ADDENDUM NO. 2

**BROADWAY ST. RIVERBANK RESTORATION/MILLPOND WEIR REPAIR
CITY OF MT. PLEASANT, MICHIGAN**

TYPICAL WEIR REPAIR DETAILS – SECTION

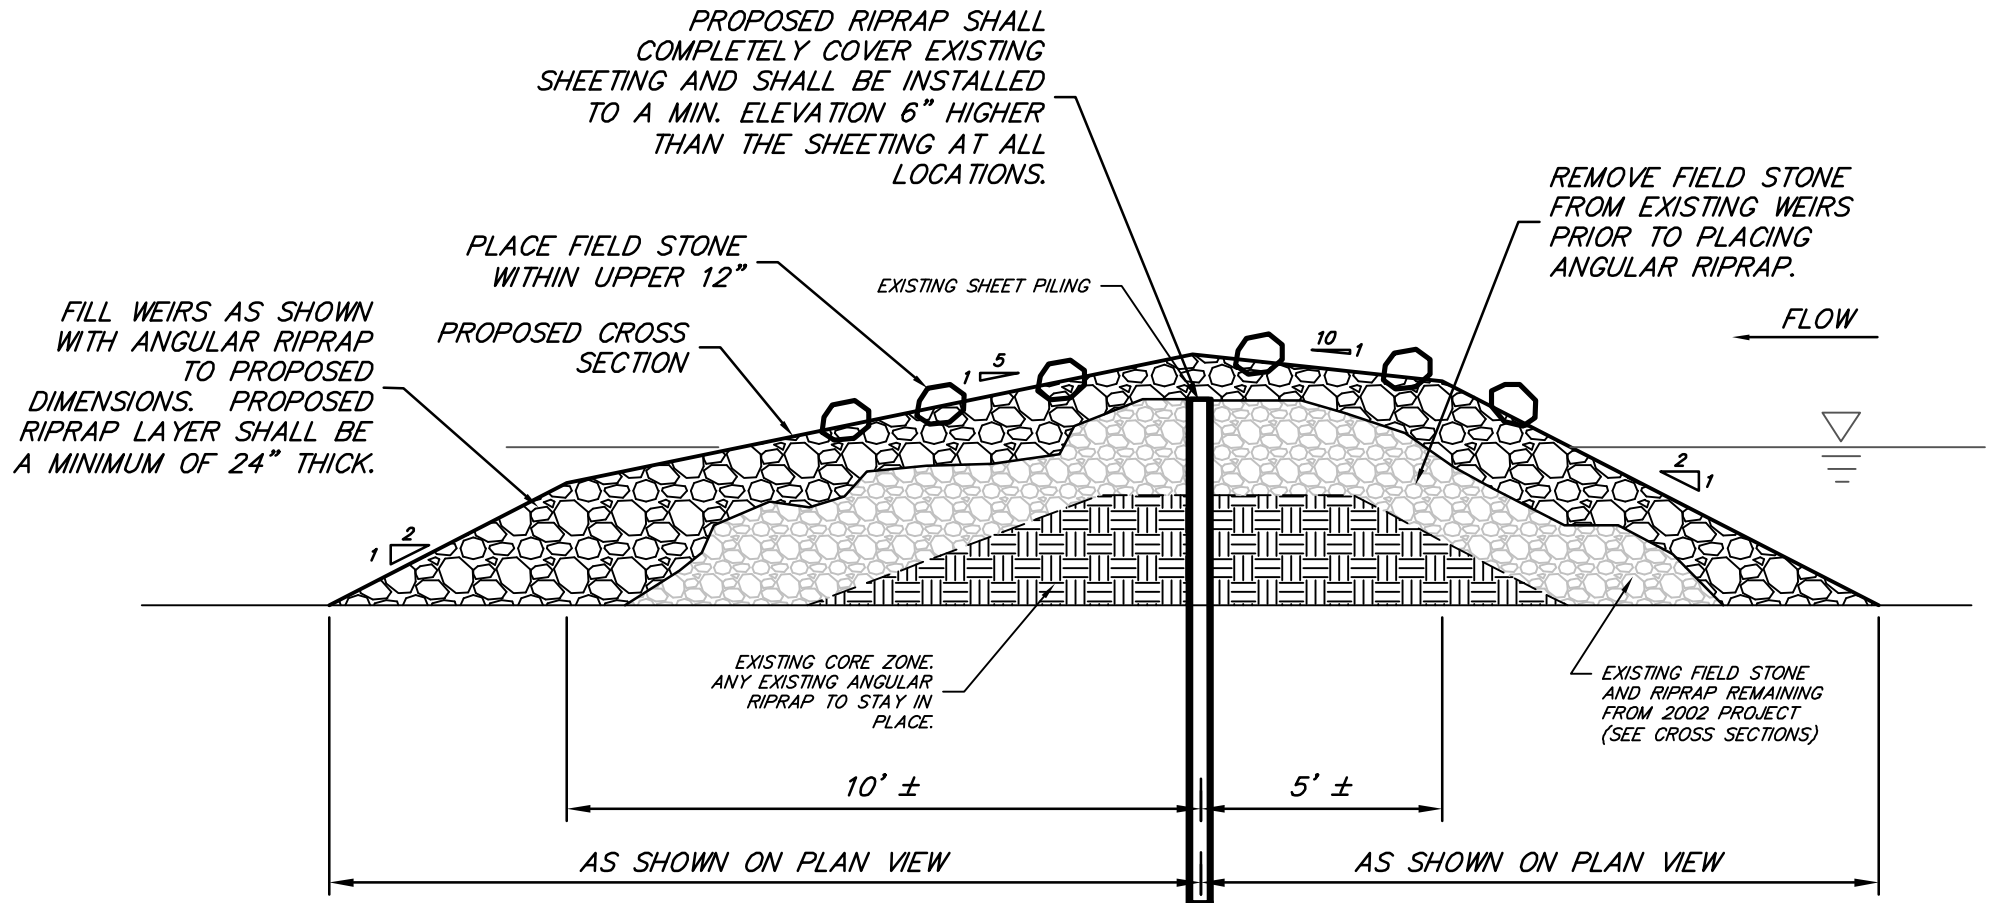
1. Addendum No. 2 has been posted to the City of Mt. Pleasant website, www.mt-pleasant.org under "Bids and Quotes" on Tuesday, June 12th, 2015.
2. Revision to Drawing Sheet 5: Enclosed is a revised detail to replace Typical Weir Repair Details – Section shown on Sheet 5 of drawings.
3. Clarification: The proposed riprap boundary in plan view on drawing Sheet 5 is the approximate boundary where the proposed riprap on the weirs will intersect the existing river bottom and banks.
4. Clarification: The proposed regrading of the beach area between Weir #1 and Weir #2, only includes regrading/smoothing out of the existing sand. It does not include bringing in any additional sand or removing any of the existing sand.
